Project: East-West Bus Rapid Transit

Contract No.: 8716  
Enactment No.: RES-23-00028  
Dollar Amount: 65,743,246.27

**File #:** 75225      **Version:** 1      **Name:** Awarding Public Works Contract No. 8716, East - West Bus Rapid Transit.  
**Type:** Resolution      **Status:** Passed  
**File created:** 12/16/2022      **In control:** Engineering Division  
**On agenda:** 1/17/2023      **Final action:** 1/17/2023  
**Enactment date:** 1/18/2023      **Enactment #:** RES-23-00028

60631225P  
A409

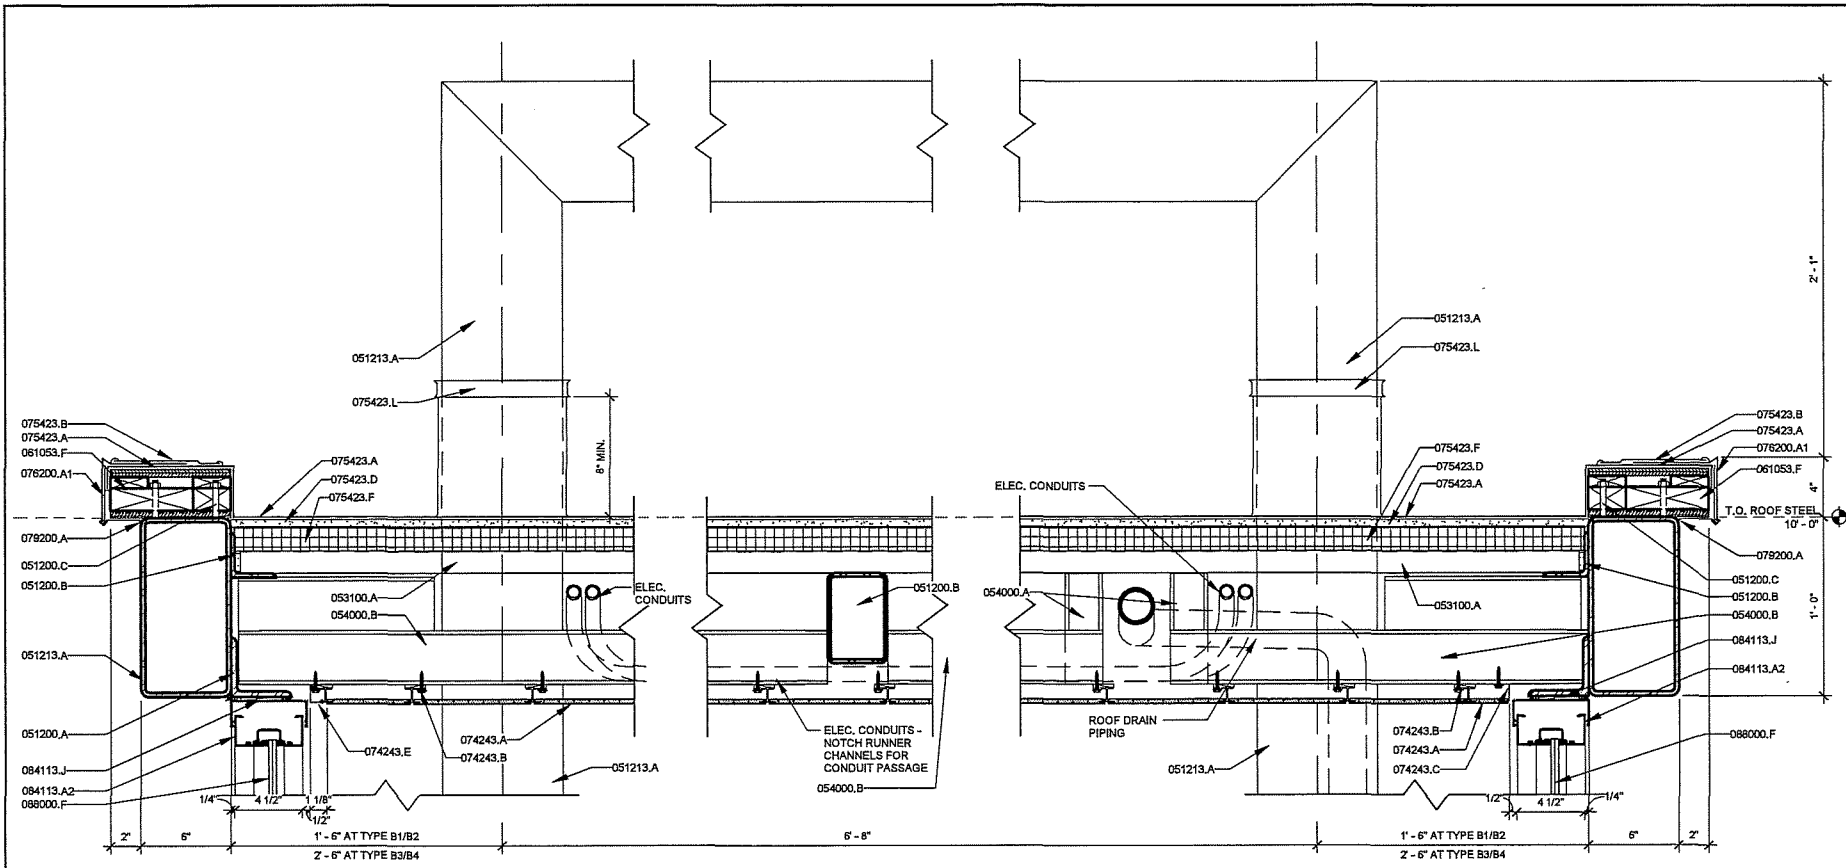
SHEET A409 (REV 11/02/2022): Inserted new sheet for guide strip detail and schedule.

SUN PRAIRIE PARK AND RIDE - ELECTRICAL POWER PLAN

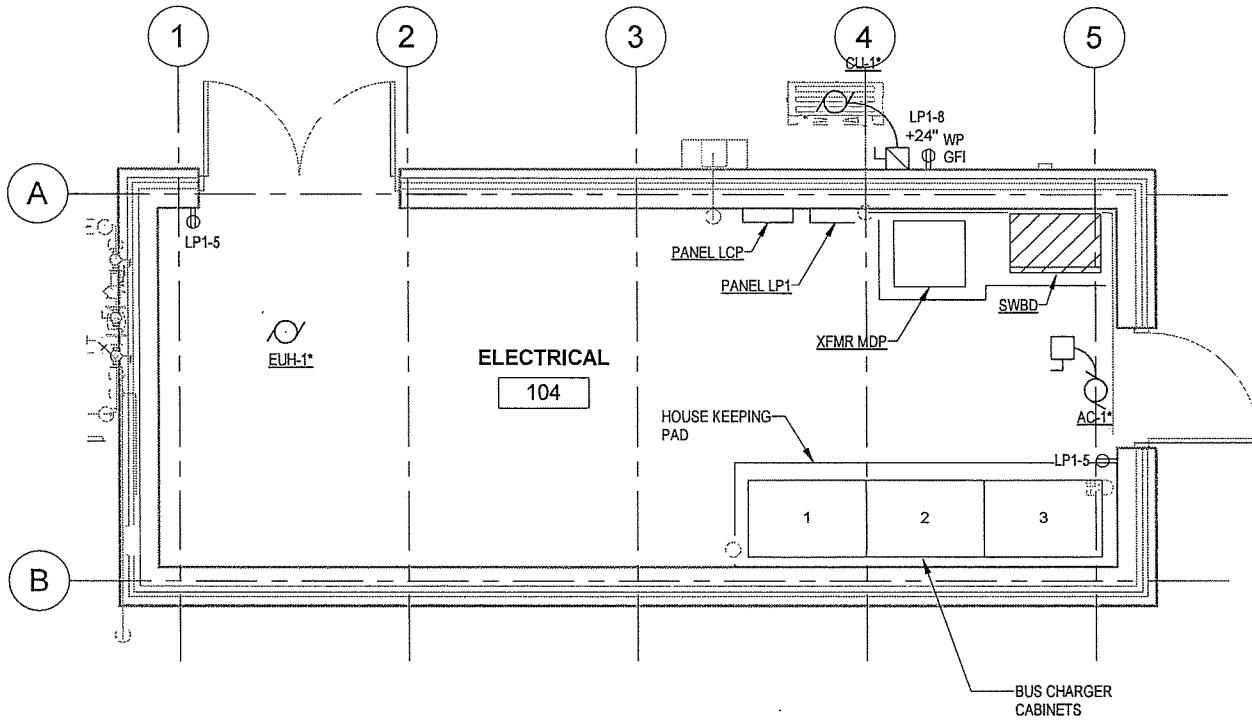
SHEET E002 (NEW 11/07/2022): Inserted new sheet Sun Prairie Park and Ride – Electrical Power Plan.

60631225P  
 CITY OF MADISON, DANE COUNTY, WI  
 CONTRACT NO: 60631225C  
 SITE PLAN: UNIVERSITY AVENUE AT SHOREWOOD BOULEVARD  
 BUS RAPID TRANSIT  
 CITY OF MADISON  
 60631225P  
 P-15W  
 REVISED 11/23/2022 ADT

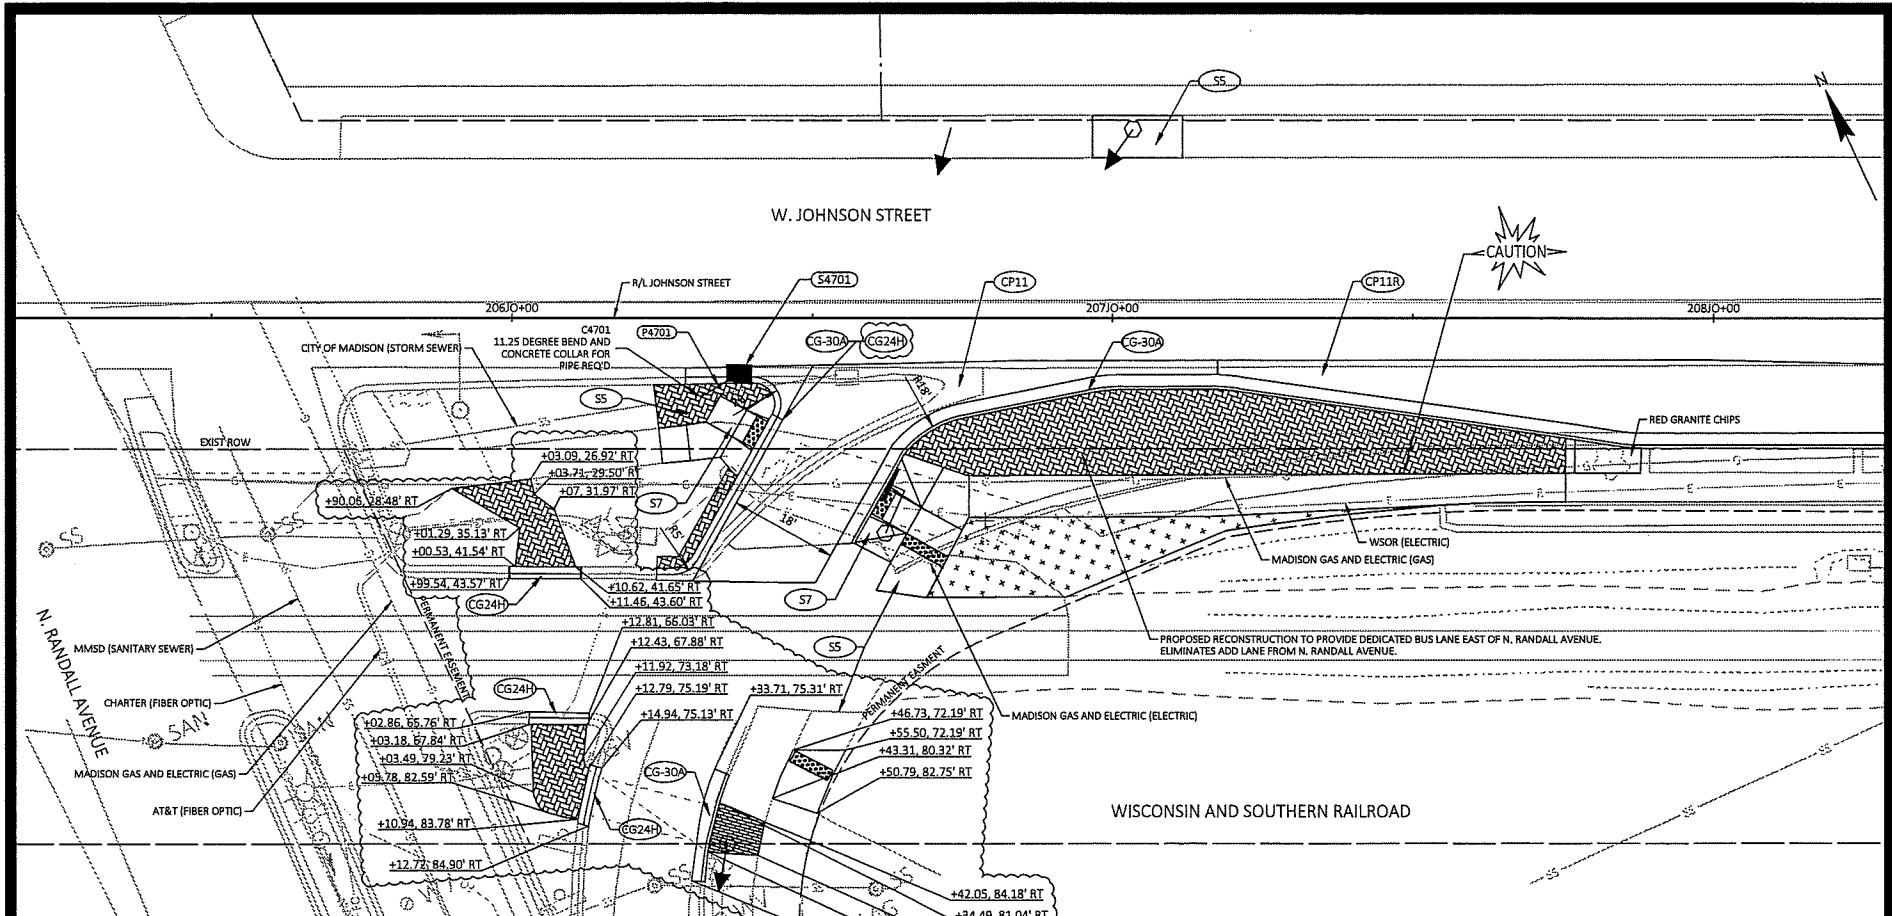
SHEET P-15W (REV 11/23/2022): Revised curb type.

60631225P  
 P20-E

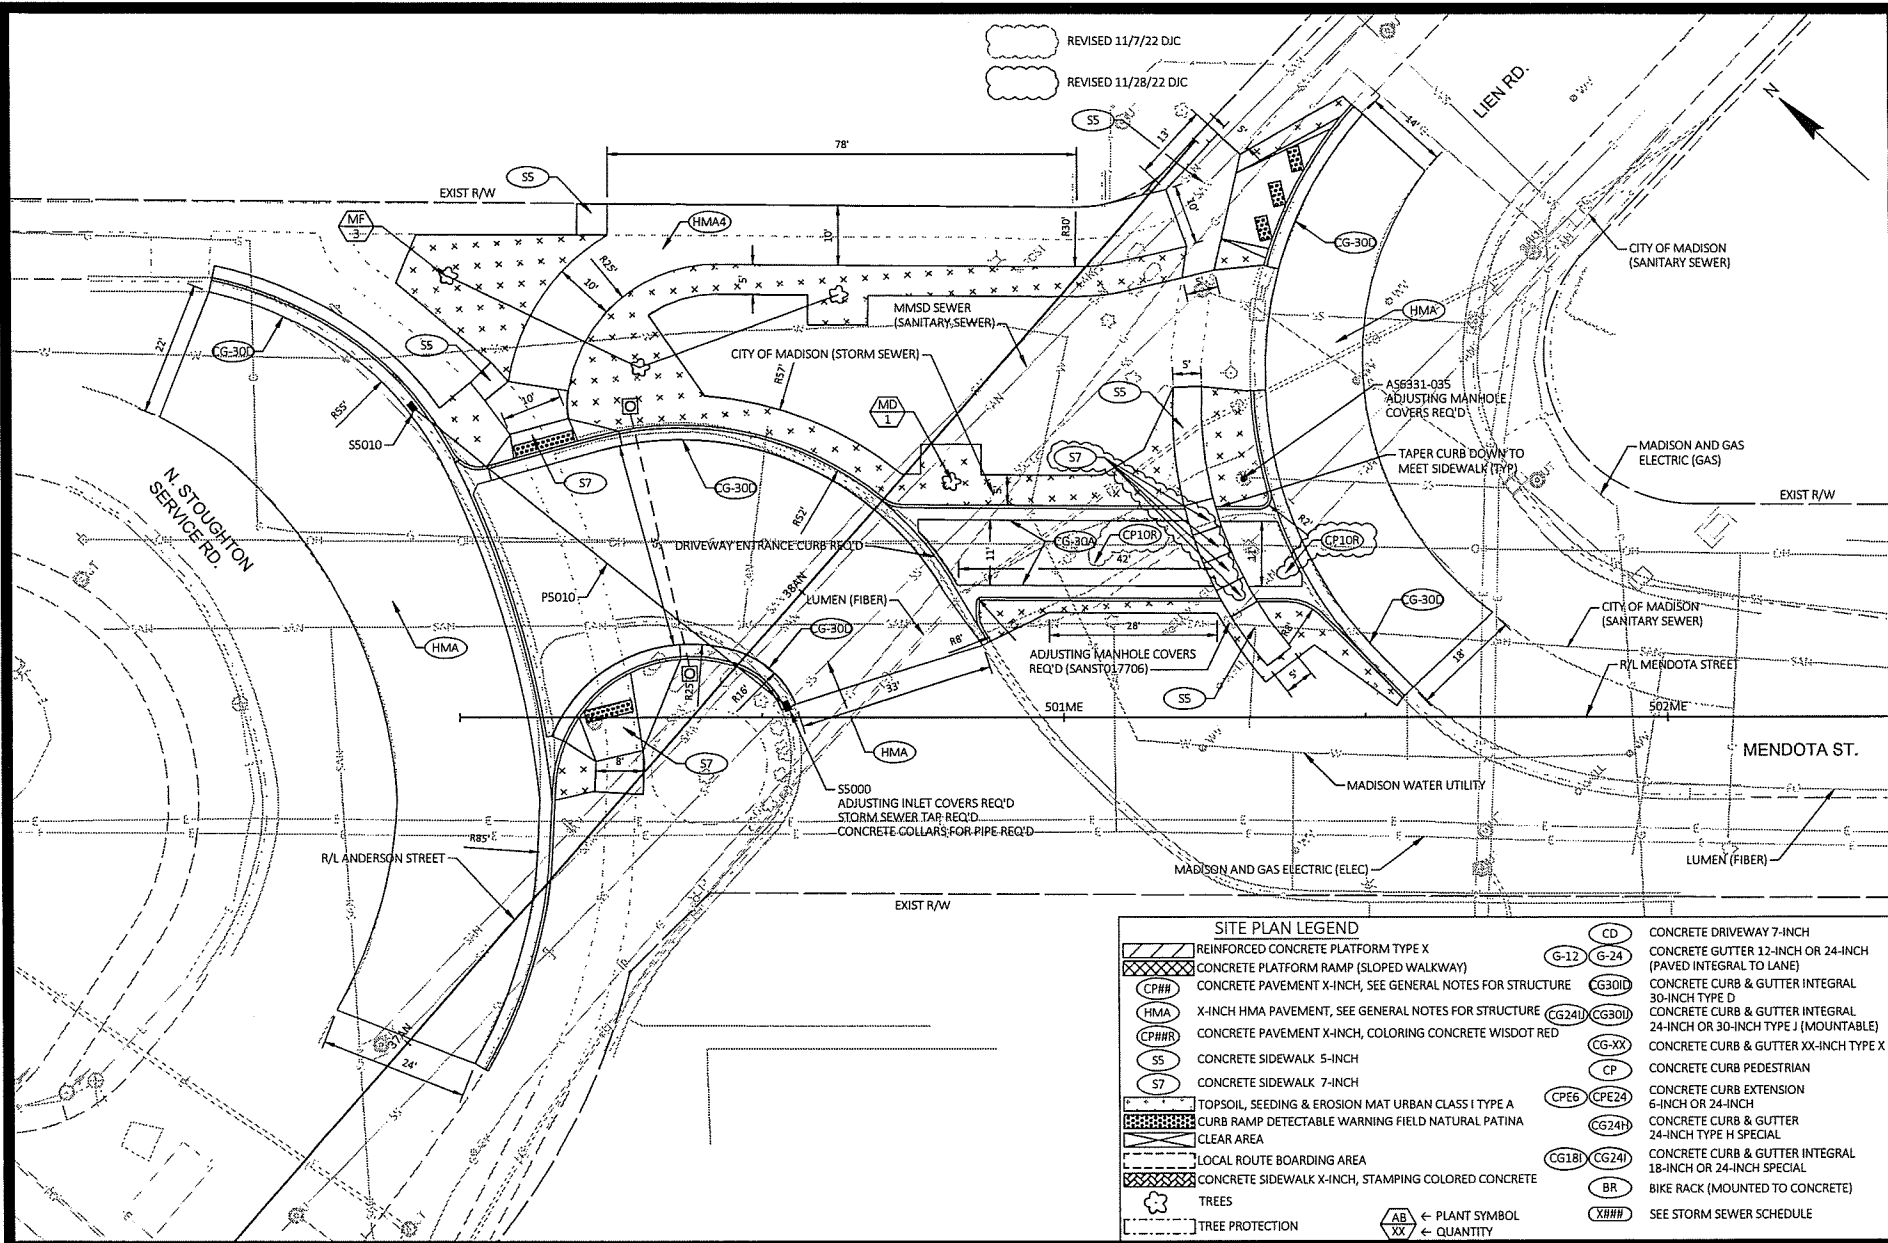
SHEET P20-E (REV 11/28/2022): Modified to add pavement labels and modify sidewalk labels for additional clarity.
